## TECHNICAL BULLETIN

Ref Document No.	TB15004	Issue No.	1
Subject	Throttle Cover		
Release Date	6 <sup>th</sup> May 2015

**Purpose** – Advise COALTRAM® owners/operators of the impact holding a magnet against the throttle pedal sensor housing.

Figure 1: throttle pedal cover installed

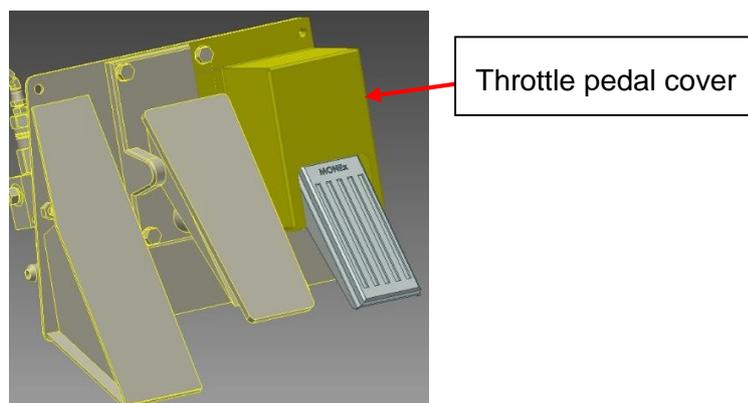
Upon request PPK have designed a cover that can be attached to the pedal assembly. The cover, made from mild steel, creates a gap around the throttle pedal sensor housing sufficient that the magnetic field, from a relatively strong magnet, is dissipated to a point that it does not affect the throttle sensor. Below is a model image showing the throttle pedal cover in yellow.

1. PPK recommends Coaltram owners/operators conduct a site based risk assessment to determine if the cover is required throttle sensor is required.
2. Install label 5520009578 if deemed necessary.
3. If cover is deemed necessary and installed - add removal of cover and clean to monthly/250 hour service schedule. Parts required for cover:
  - 1 off throttle pedal shroud (Part # 5520009569)
  - 1 off throttle pedal shroud under plate (Part # 5520009570)
  - 4 off M4 nyloc nut (Part # 3015)
4. The components will be available 18<sup>th</sup> May 2014.
